May 22, 1991

Re: Tampa Electric Company (TEC)
Hardee/Pebbledale Electrical Transmission Line
PA 89-25
Additional Information Request

FIGURE 22

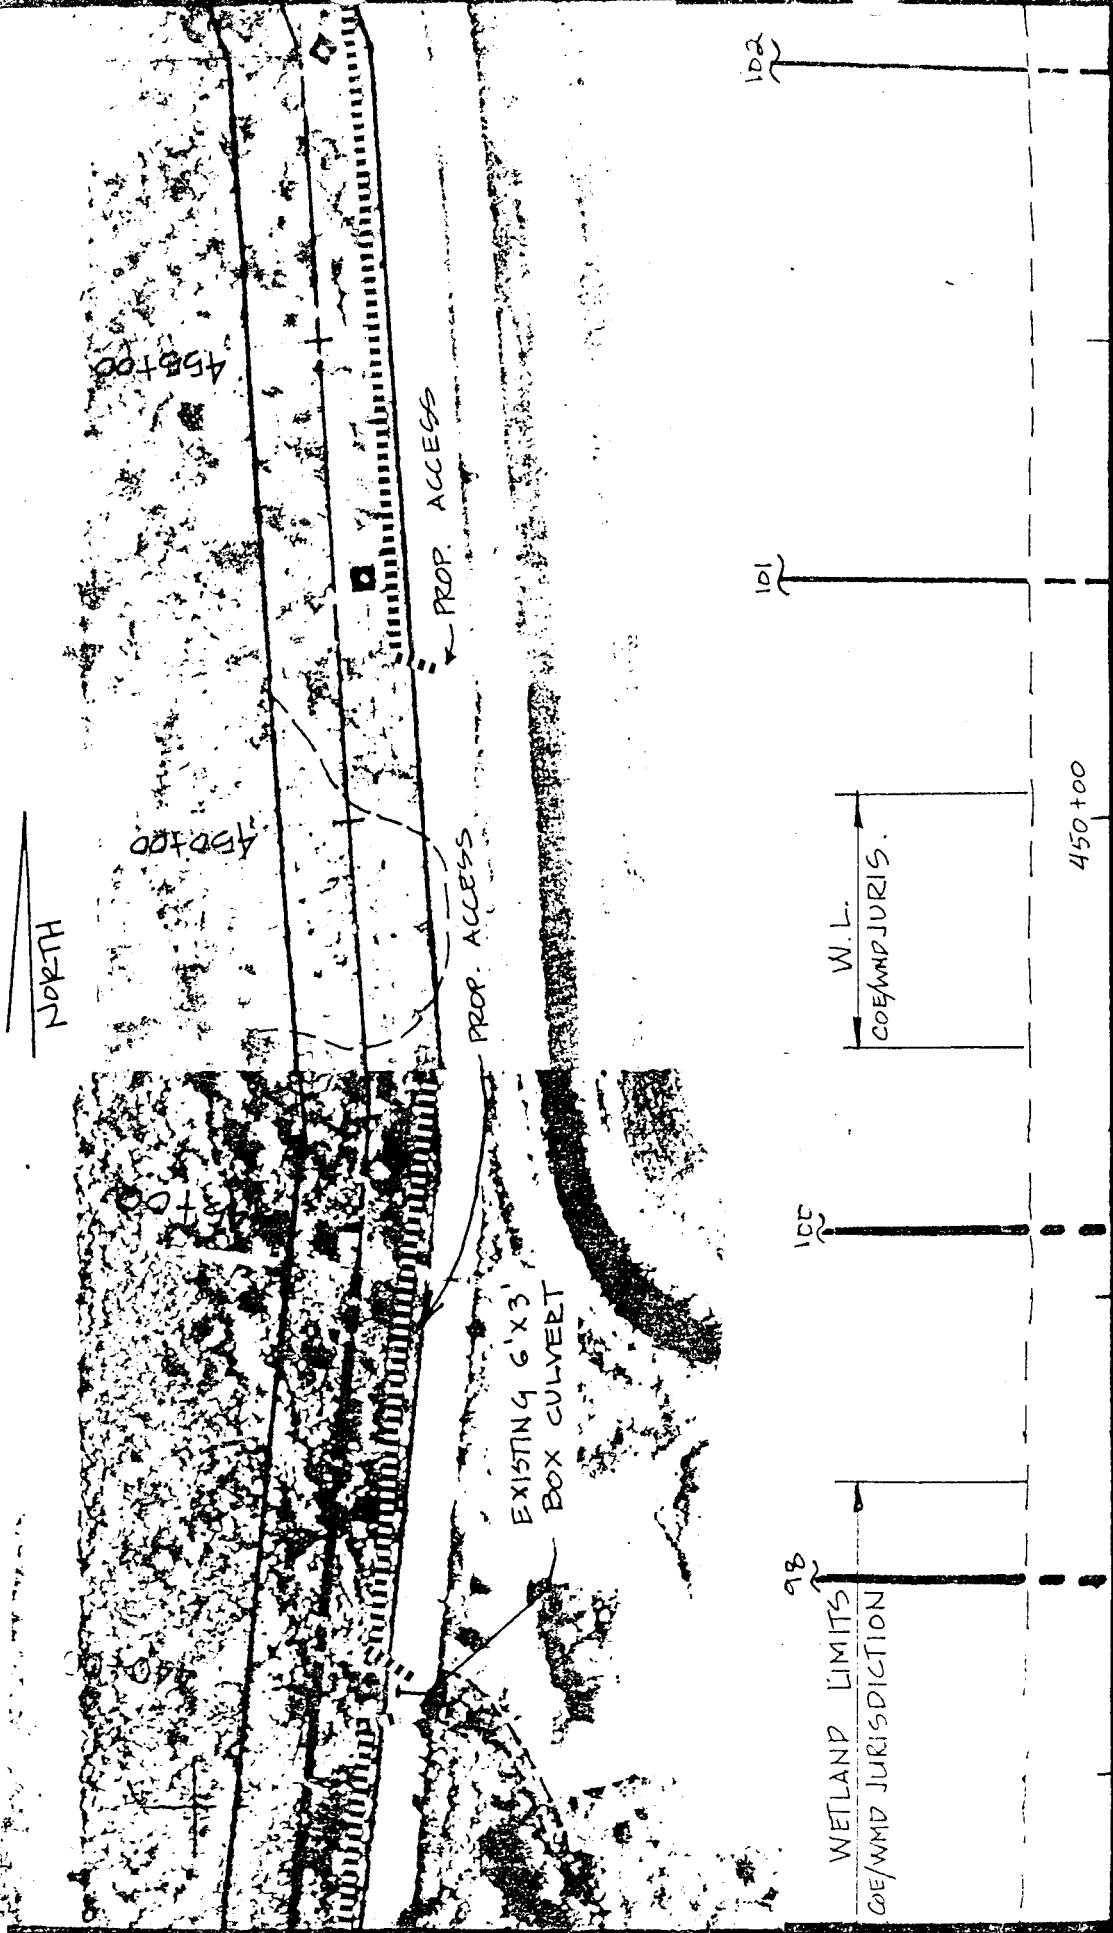
Enclosed with this letter are four signed and sealed copies of figures 22, 23, and 33 which have been revised to accurately show the proposed facilities of this project. Figures 23 and 33 are now shown with the access road clearly separate from the ditch and pond areas, respectively. On figure 22, a small culvert is shown which will be placed in the field during construction if any recent evidence of upland water flow is present. Our field investigations of this new access road location have shown the area to grade out into uplands from the adjacent ditch to the north. We do not expect that a culvert will be necessary.
